BGA TECHNICAL COMMITTEE

TECHNICAL NEWSHEET 11/12/95

PART 1 Airworthiness "AGGRO"

N° 20-18 Révision 1

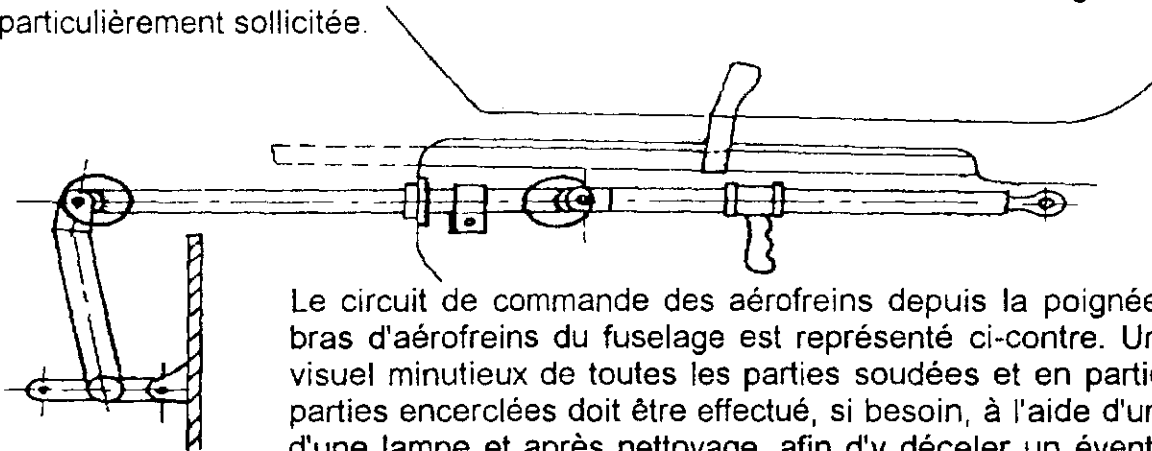
OBJET : COMMANDE D'AEROFREINS DANS FUSELAGE.

BUT : Détecter des éventuelles criques au niveau du circuit de commande d'aérofreins dans le fuselage.

Le circuit de commande des aérofreins depuis la poignée jusqu'au bras d'aérofreins du fuselage est représenté ci-contre. Un contrôle visuel minutieux de toutes les parties soudées et en particulier des parties encerclées doit être effectué, si besoin, à l'aide d'un miroir et d'une lampe et après nettoyage, afin d'y déceler un éventuel début de crique.

Une telle inspection n'ayant, semble-t-il, pas été systématiquement effectuée lors des visites périodiques, nous recommandons d'effectuer le contrôle décrit ci-dessous sur chaque planeur lors de la prochaine visite de petit entretien.

Cette inspection doit être systématiquement effectuée lors de chaque visite annuelle et de chaque grande visite.

En cas de constatation de crique, prendre contact avec S.N. CENTRAIR pour l'informer du défaut constaté. Une réparation du planeur doit alors être réalisée avant tout nouveau vol.

N° 101-16 Révision 1

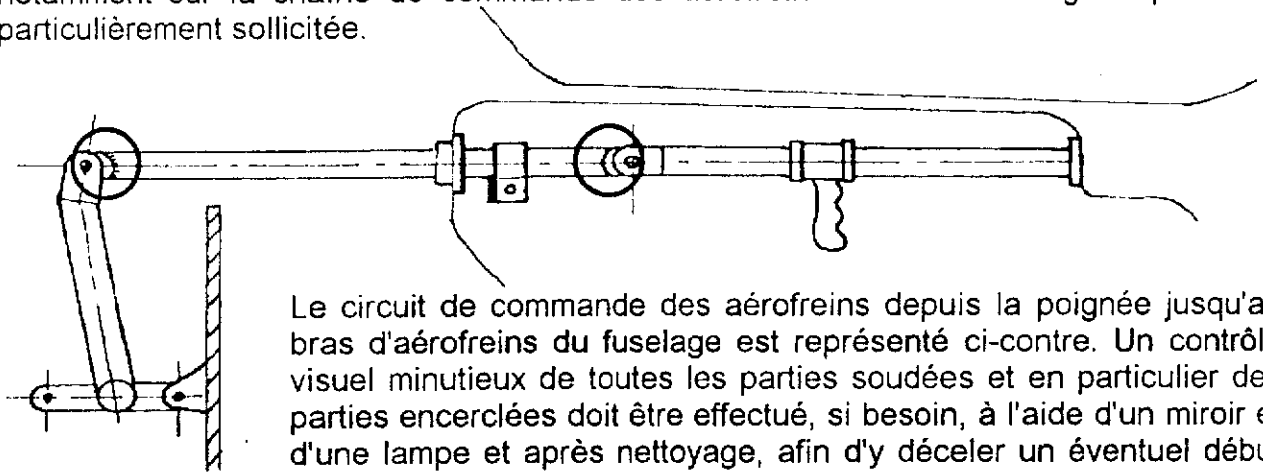
OBJET : COMMANDE D'AEROFREINS DANS FUSELAGE.

BUT : Détecter des éventuelles criques au niveau du circuit de commande d'aérofreins dans le fuselage.

Le circuit de commande des aérofreins depuis la poignée jusqu'au bras d'aérofreins du fuselage est représenté ci-contre. Un contrôle visuel minutieux de toutes les parties soudées et en particulier des parties encerclées doit être effectué, si besoin, à l'aide d'un miroir et d'une lampe et après nettoyage, afin d'y déceler un éventuel début de crique.

Une telle inspection n'ayant, semble-t-il, pas été systématiquement effectuée lors des visites périodiques, nous recommandons d'effectuer le contrôle décrit ci-dessous sur chaque planeur lors de la prochaine visite de petit entretien.

Cette inspection doit être systématiquement effectuée lors de chaque visite annuelle et de chaque grande visite.

En cas de constatation de crique, prendre contact avec S.N. CENTRAIR pour l'informer du défaut constaté. Une réparation du planeur doit alors être réalisée avant tout nouveau vol.

Drawing of flaperon drive in fuselage near landing gear box, parts list and exploded view for assembly.

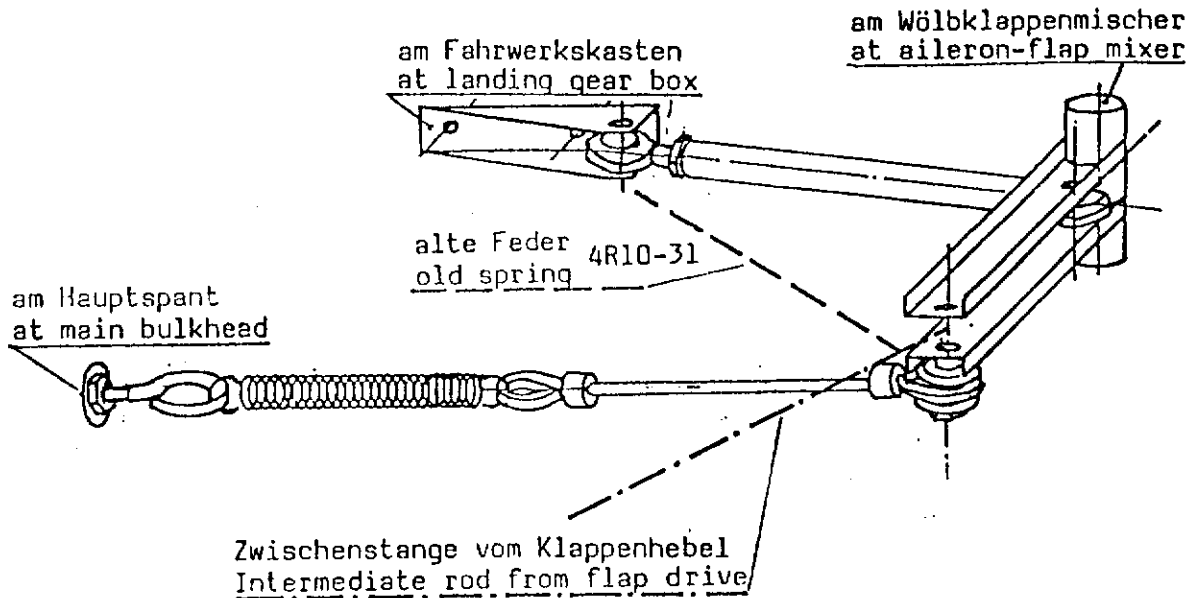
Subject : Spring in fuselage flap drive near landing gear box

Reason : The spring 4R10-31 (cadmium plated steel) in the flap drive may fracture due to fatigue, resulting in high flap control force at negative flap position.

Instructions : Spring 4R10-31 to be exchanged according to drawing 1BR-3b against longer spring (RZ 141 EI, corrosion resistant steel), also forward mounting of spring moved from landing gear box to main bulkhead. See pages 2 to 4 of this TB (excerpt of drawing 1BR-3b) for details, material and installation instructions.
